Check report by Sales + CR after finishing stage IV (Apartments)

Fiat No	H-105	Other		Sl. No.	43572
Company-Modi	Modi Realty	Project		Phase	
Realty Mallapur llp	Mallapur llp		Gulmohar Residency	Date	12-05-25
Prepared by	G.B.Ram Babu	Sign		Date	12-05-25
Project Manager	Ahmed	Sign	<i>Ahmed</i>		
Stage II report no.					
Checked By MD on		MD Sign		For filling	☐ Yes ☐ No

Quality Control Check Report, Stages: After Finishing Stage III (Apartments)

GULMOHAR RESIDENCY

Description	Direction 	Owners & Developers :	Date :	16.09.20	Promoted by
		Modi Reality Mallapur LLP	Prepared By :	Jayapradha	Modi Properties Pvt Ltd
		Project Name & Phase :	Approved By :	Soham Modi	
		Gulmohar Residency	Scale :	N.T.S	
PLUMBING PLAN-1360 Sft (A1-TYPE)

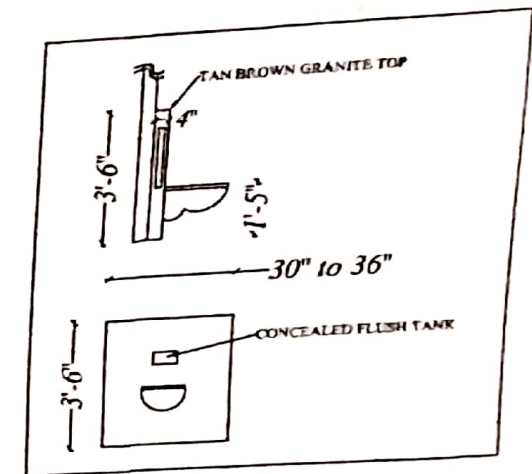
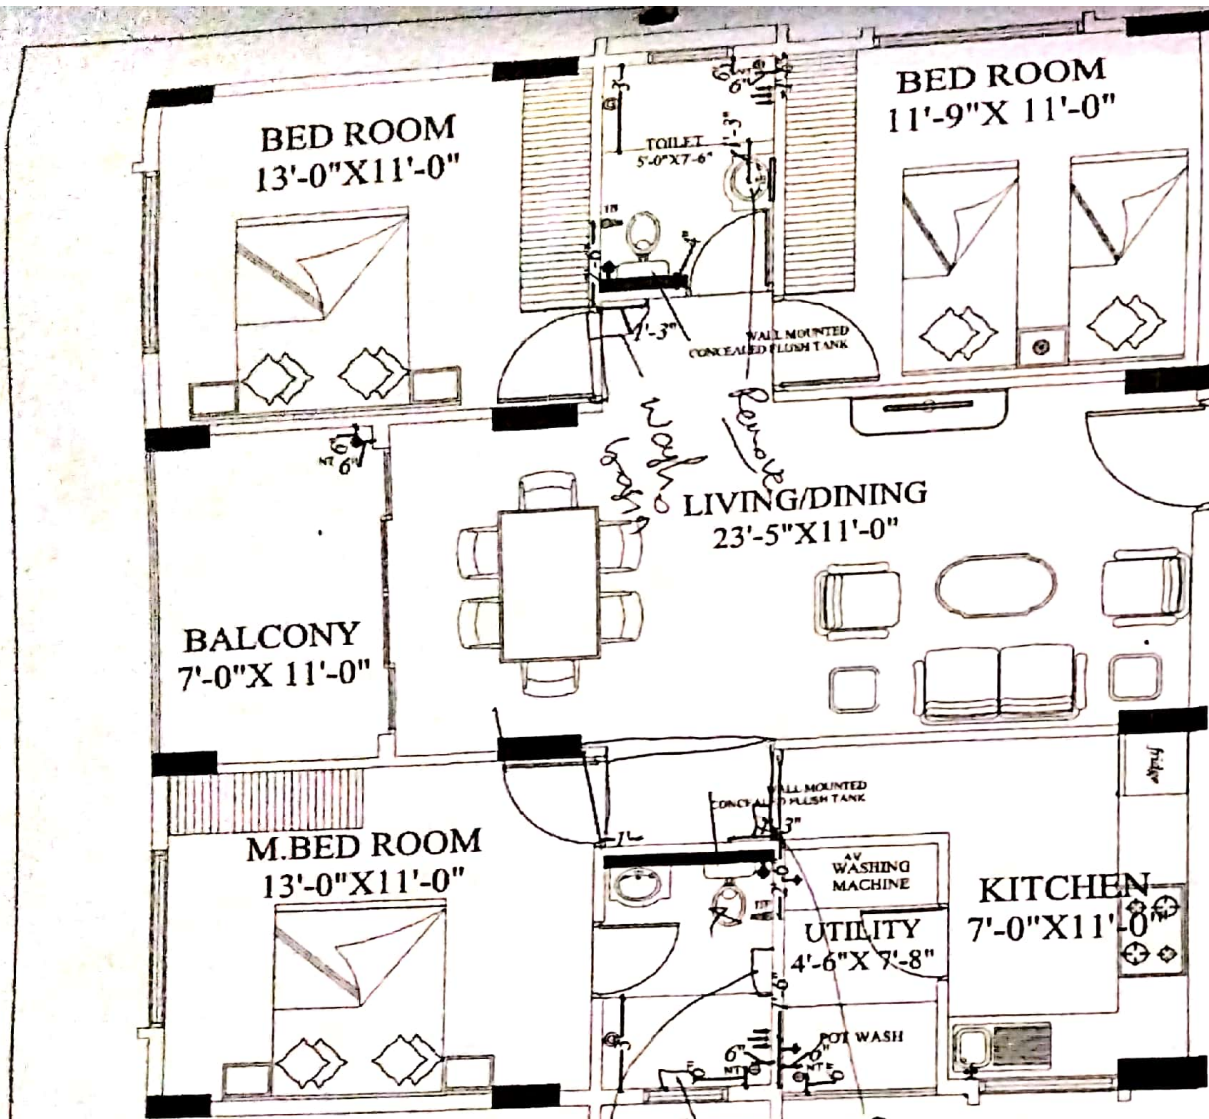
- ③ M.T. — Full plumbing changes.
- ④ Wash basin point extra.
- ⑤ Extra sink provision.

- Demolishing of kitchen platform add extra cost
- chimney hole in kitchen at extra cost
- Kitchen full plumbing points changed

- 1) Carby flooring - Carby Rosso
- 2) Utility flooring - ~~Balance White~~ Carby Rosso
WEN - ~~Carby Rosso~~ Carby Rosso
- 3) Utility door changes - 2 times
1 x 3' door frames fixed

- 1) 2 bathroom floor tiles refurd.
- 2) Kitchen chudo tiles refurd
- 3) 2 wash basins refurd.
- 4) 2 shower refurd.

Description		Direction	Owners & Developers	Date	21.09.2020	Prepared by	Jayaprabha	Modi Properties Pvt Ltd
ELECTRICAL PLAN - 1360 sqm FLATS-A1 TYPE		N	Modi Realty Mallapur LLP	Approved By	Sobam Modi	NTS	NTS	Phone: +91-40-66335551
			Gulmohar Residency	Scale

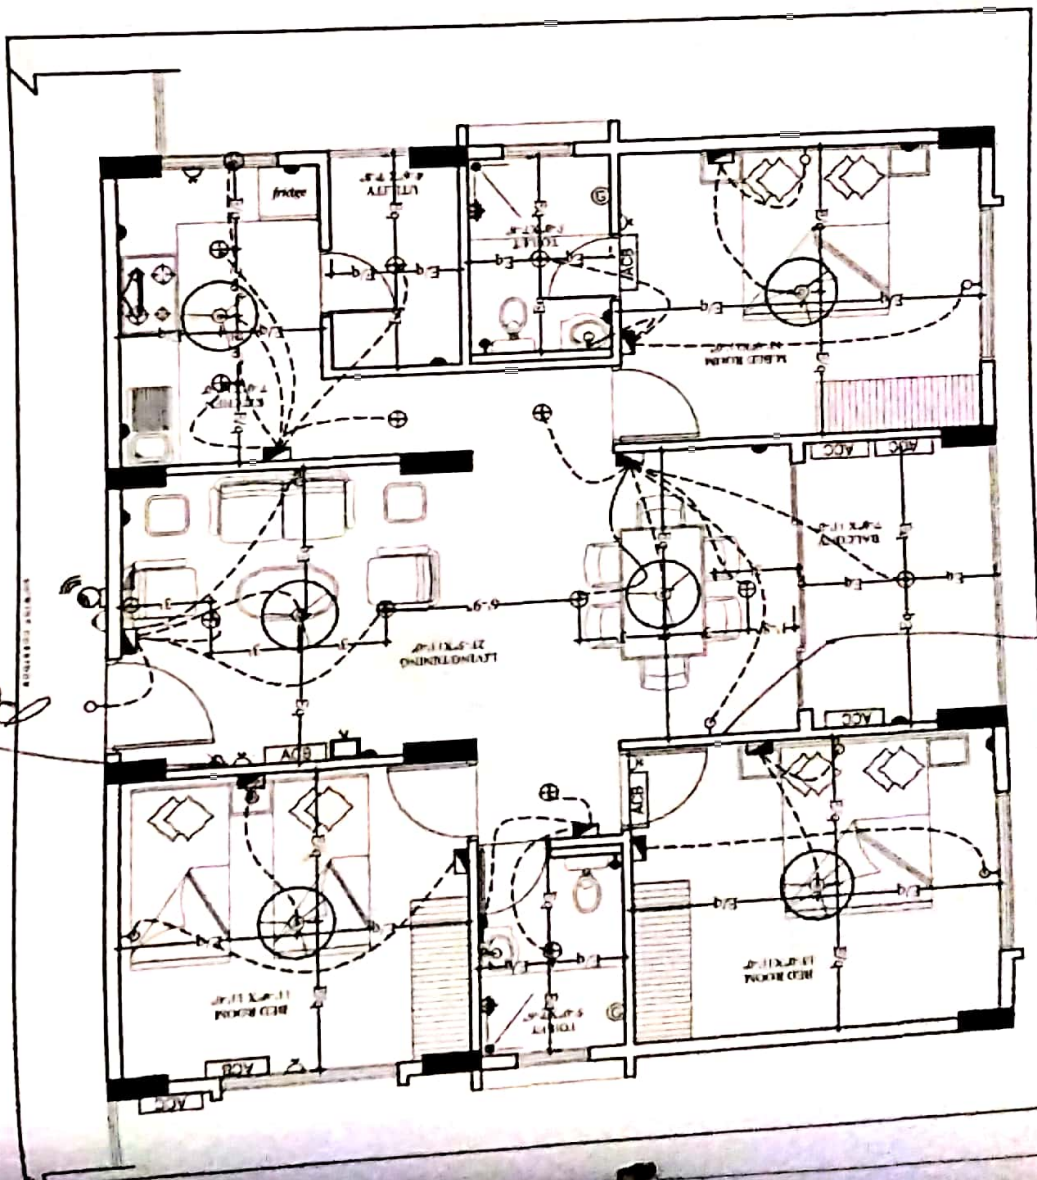
- ① 8 Mould Box shifting to down side. x
- ② Extra points in all rooms. x

Extra
point

Extra point
